YAGI BANGLADESH GARMENTS LTD.

HP TOWER, NORTH BARON, P.O: ALIYA MADRASA, P.S: ASHULIA, UZ: SAVAR, DIST: DHAKA
(23.939178 N, 90.298774 E)

Observations

Design Drawing

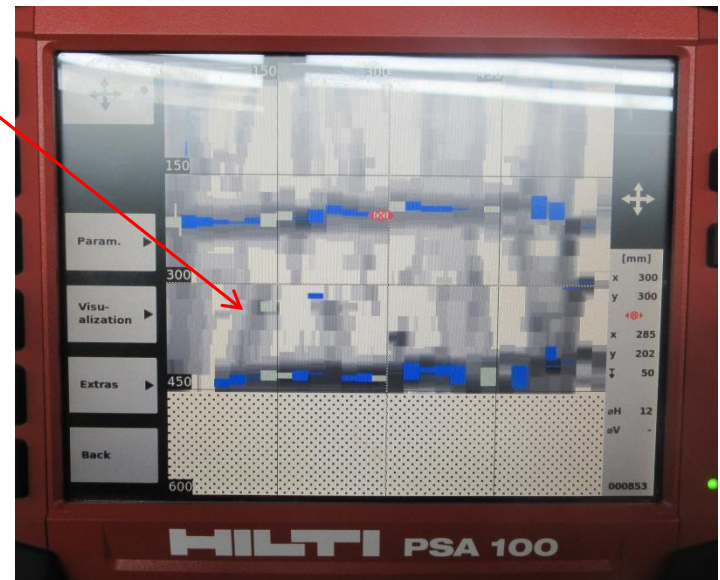
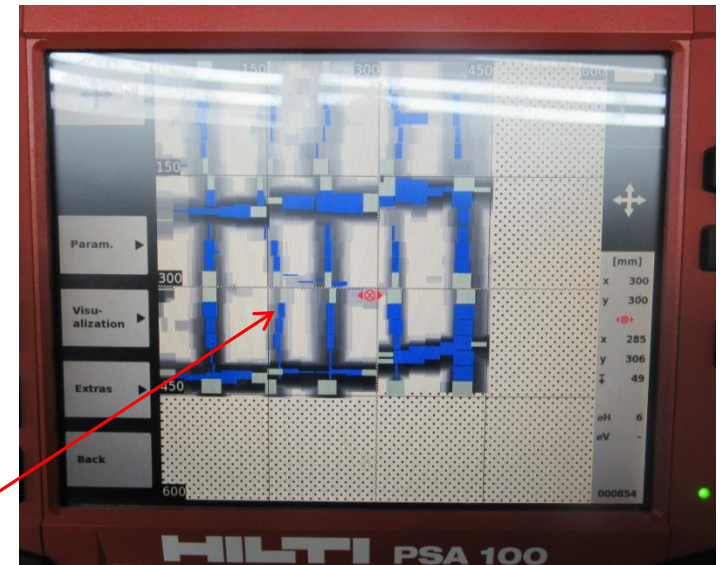
Some of the column rebars were exposed at roof level. Some of them were not matching with the design drawings. Approximately two bars were less.

Item No.	Observation	Recommended Action Plan	Recommended Timeline
9	Discrepancies between Design Drawings and Observations	Column dimensions and reinforcement ratios are found not to be matching with the design drawings. As-built drawings should be prepared by the Building Engineer.	6-weeks
10	Discrepancies between Design Drawings and Observations	Information on the as-built drawings should be compared with the data used for the detailed assessment and necessary further studies to be carried out.	6-months
11	Discrepancies between Design Drawings and Observations	Necessary alterations to the structural members to be done regarding the results of the detailed assessment study.	6-months
12	Exposed Column Rebars and Ponding at Roof Level	The construction have been completed however some of the column rebars are still exposed.	6-weeks
13	Exposed Column Rebars and Ponding at Roof Level	Ponding have been observed at roof.	6-weeks

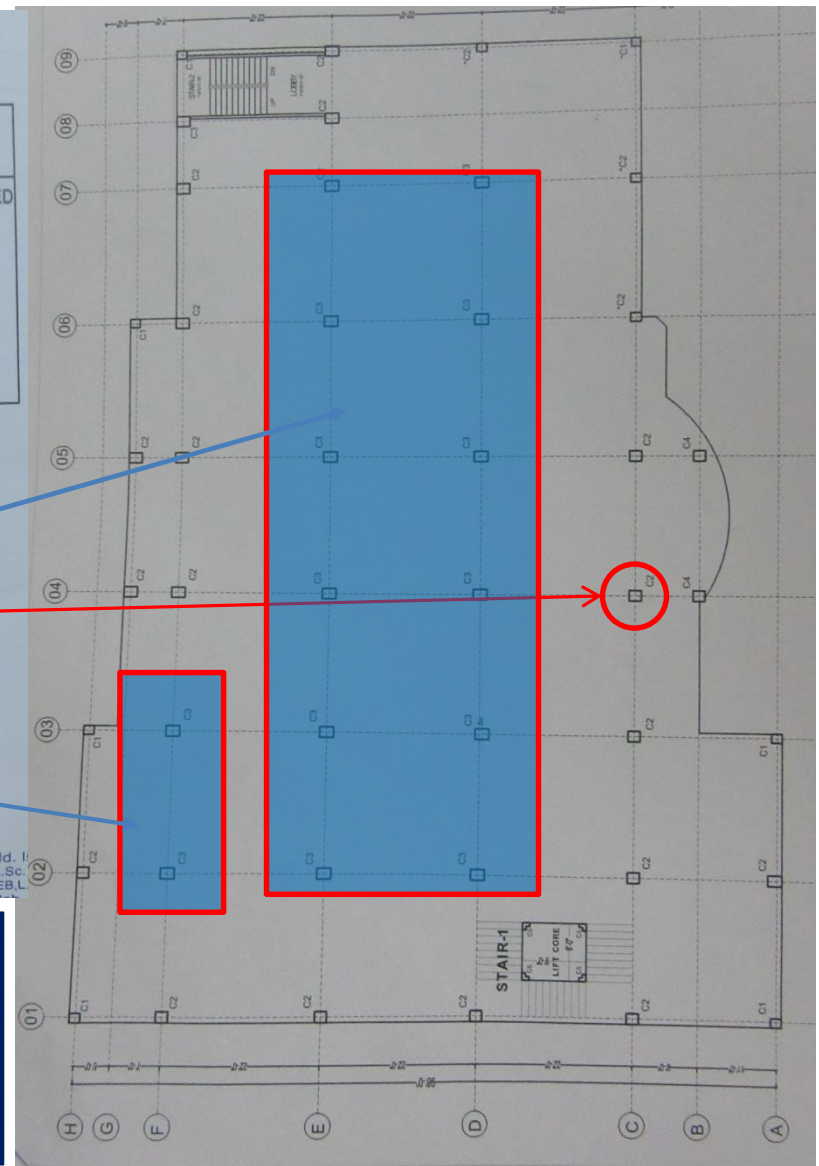
Typical C3 column dimension is measured as 18" by 24" where as it is shown as 20" by 24" on the design drawings. One of the C2 type column dimension also not matching with the design.

Hairline Cracks at Beams and Slabs

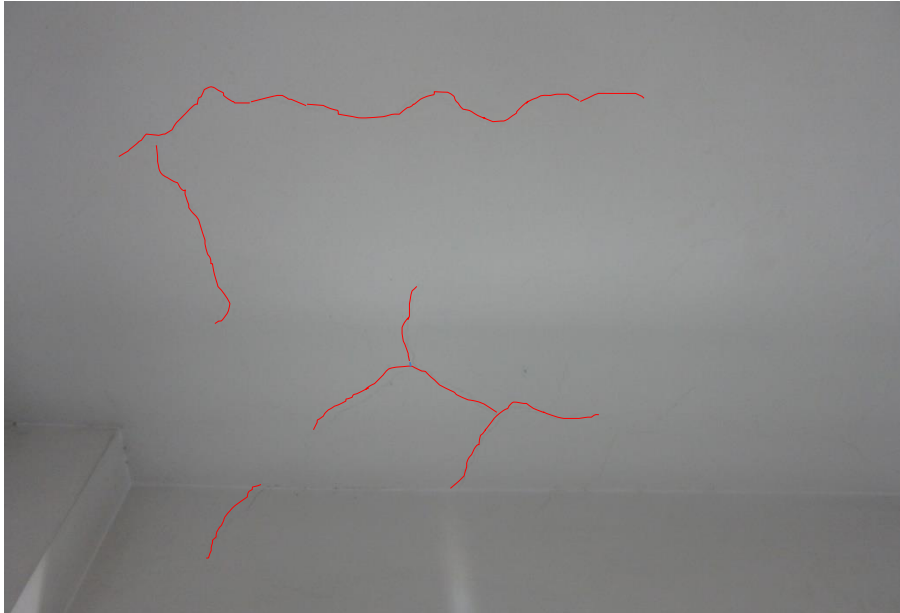
Cracks observed at some slabs.

Cracks observed at almost all beams.

8	Hairline Cracks at Beams and Slabs	Necessary structural alterations should be done based on the outcome of the investigations.	6-months

Stres Level at Columns

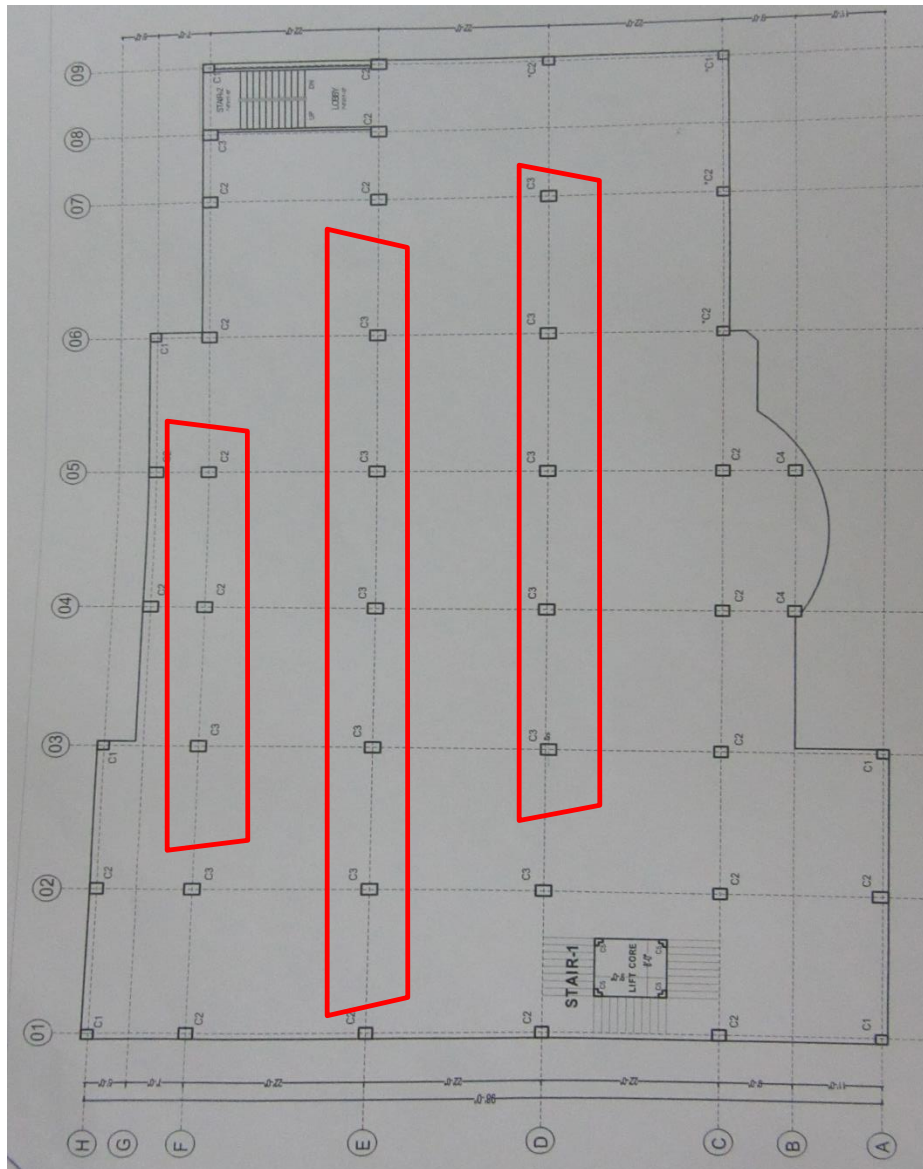
Columns at marked areas
have found to have high
stress levels.

Item No.	Observation	Recommended Action Plan	Recommended Timeline
1	Stress Level at Columns	Building Engineer to review design, loads and stresses in columns in the area noted.	6-weeks
2	Stress Level at Columns	Building Engineer to verify in-situ concrete strength by taking 100mm diameter cores from 4 columns.	6-weeks
3	Stress Level at Columns	Building Engineer to verify grade of steel reinforcement and no. and diameter of main column bars.	6-weeks
4	Stress Level at Columns	Make structural alterations if required as advised by Engineer.	6-months
5	Hairline Cracks at Beams and Slabs	Monitoring should be done to observe propagation and changes in the width/length of the cracks.	6-weeks
6	Hairline Cracks at Beams and Slabs	Cracks to be checked for any structural damage.	6-weeks
7	Hairline Cracks at Beams and Slabs	Loading plan to be prepared for warehouse and accessory store at the first floor to control the loading limits.	6-weeks

Disorganized Loading at Some Areas

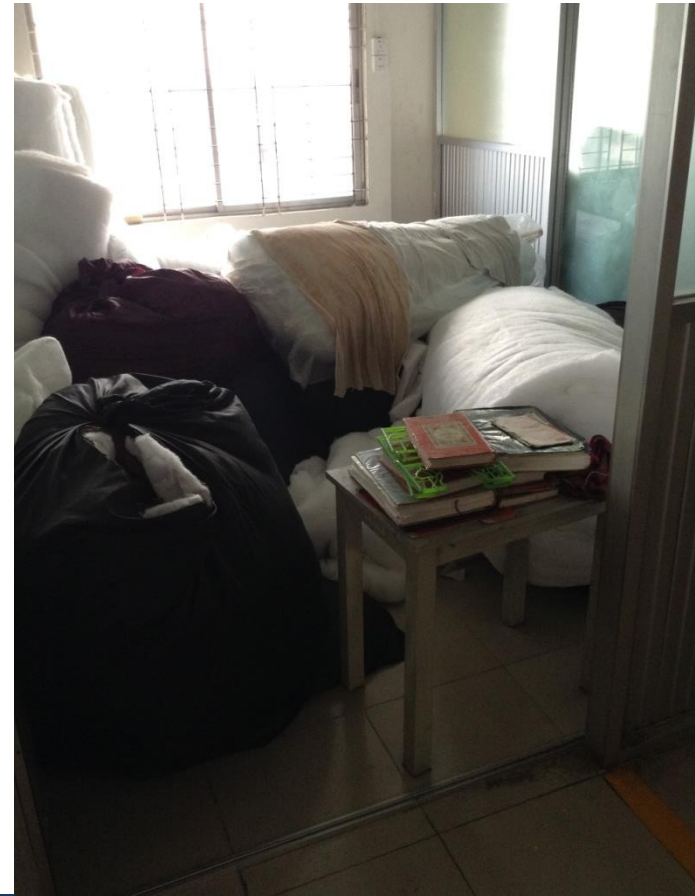
No load plan for storage area in different floors
